Planning and Zoning Board

CASE NUMBER: Z17-00384
LOCATION/ADDRESS: The 2800 to 2900 block of South Signal Butte Road (west side) and the 10600 to 10800 block of East Guadalupe Road (south side)
GENERAL VICINITY: Located on the south side of Guadalupe Road and the west side of Signal Butte Road.
REQUEST: Rezone from AG to LC; and Site Plan Review.
PURPOSE: This request will allow the development of a group commercial center.
COUNCIL DISTRICT: District 6
OWNER: Walgreen Arizona Drug Co.
APPLICANT: Dennis Newcombe, Beus Gilbert PLLC and Cain Garcia, RKAA Architects Inc.
STAFF PLANNER: Wahid Alam, AICP-Planner II

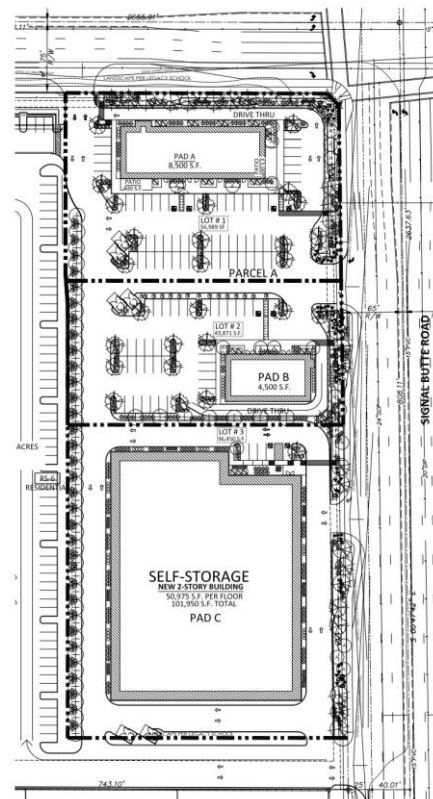
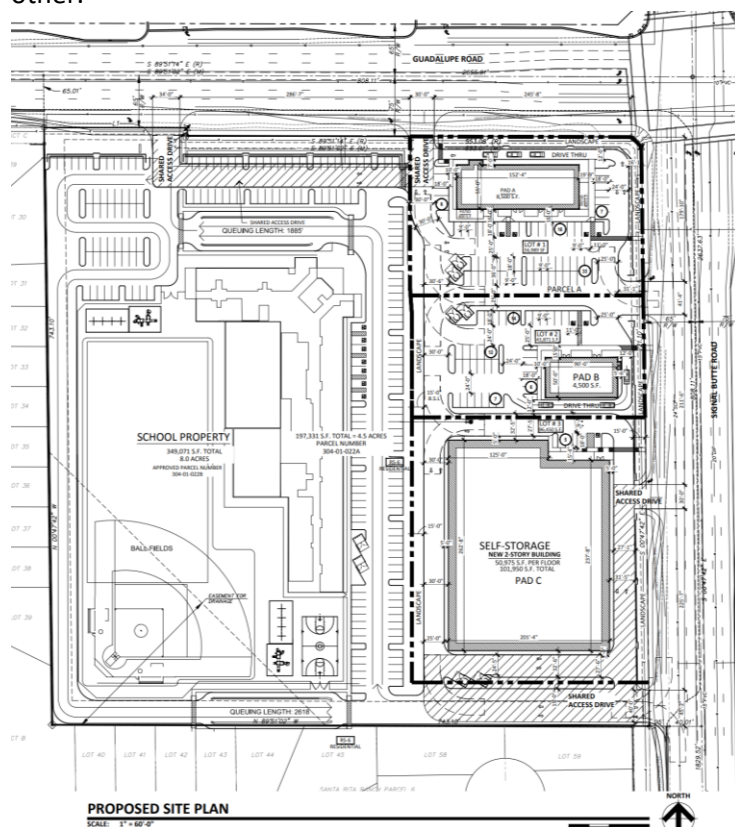
The proposed site plan shows three lots next to each other. The proposed development is not organized or grouped as a cohesive, visually integrated, commercial development. The proposal is laid out for three buildings on three pad sites with no design organization except shared vehicular access at some points. This has been a fairly typical type of layout for properties like this. A goal of the General Plan is change this pattern of building and to build sites like this in a way that increases connectivity, walkability, sense of place, and neighborhood. The proposed uses need better organization of the site plan for a group commercial. The three buildings should belong to one another not just next to each other.

The proposed development needs to organize all the land uses as one development in site plan/layout, building design and landscaping. In addition, a design/development theme will tie or bind all the uses proposed so that when the development is built in phases there will be integration and it will look like a single development. The applicant has agreed to revise the site plan in a manner to bring the buildings on pad sites A and B closer together to frame the northern driveway from Signal Butte (Condition #5a

The applicant has not submitted any floor plans for the proposed buildings. Therefore, it is difficult to determine for sure whether or not the proposed foundation base is adequate per zoning code (Condition #5c).

The Site Plan and Landscape Plan for the mini-storage are not the same. According to elevations there are roll-up doors along west and south elevations, but the Landscape Plan shows plant materials along these sides of the building. In discussion with the applicant staff has been told the elevations are correct, there will not be landscaping in these areas. An alternate paving material is needed next to the building on the south and west sides to distinguish the drive aisle from the loading areas next to the building. (Condition #5d).

With the current site plan, there are potential conflicts with circulation around pad site A. One concern is the traffic stacking for the drive-thru and the vehicles backing from parking stalls along the east elevation of the building in pad site A. The shared driveway access from Guadalupe Road has the potential conflict with drive-thru exit traffic due to very little depth/throat for traffic exiting the drive-thru. These issues should be resolved with the relocation of the building to the south as described above. The redesign will need to have a throat depth for the driveway from the Guadalupe Road ROW that meets or exceeds that for the access to the school to the west. (Condition #5e).

There is no internal pedestrian connectivity between the three buildings. Also, there is no pedestrian connectivity shown along the shared access driveway from Signal Butte Road. Show the pedestrian connectivity between the school and the Signal Butte Road. Provide internal pedestrian connectivity with refuse area between the proposed three buildings (Condition #5f and 5g).

- a) **Relocate the building on PAD A to the south so it frames the north side of the driveway access located between Lot 1 and Lot 2.**
 - b) **Relocate the building on Pad B to the north so it frames the south side of the driveway access located between Lot 1 and Lot 2.**

- c) **Compliance with foundation base requirements from Sec. 11-33-5 of the Mesa Zoning Ordinance.**
 - d) **Stamped asphalt or similar material on 5' of the paved surface located next to the rollup doors on the west and south sides of the self-storage building. The surface material must be distinctly different from the 25' wide driving surface. The total width of the paved surface is 30'.**

- e) **A throat depth, for the shared access drive along Guadalupe Road, that meets or exceeds the throat depth for the access drive to the school located to the west.**

- f) **An internal pedestrian connection between PAD A and PAD B and between PAD B and Pad C.**
 - g) **A 6' wide pedestrian connection from Signal Butte Road to the school to the west. The pedestrian connection to be located along the shared access drive that is south of PAD C.**
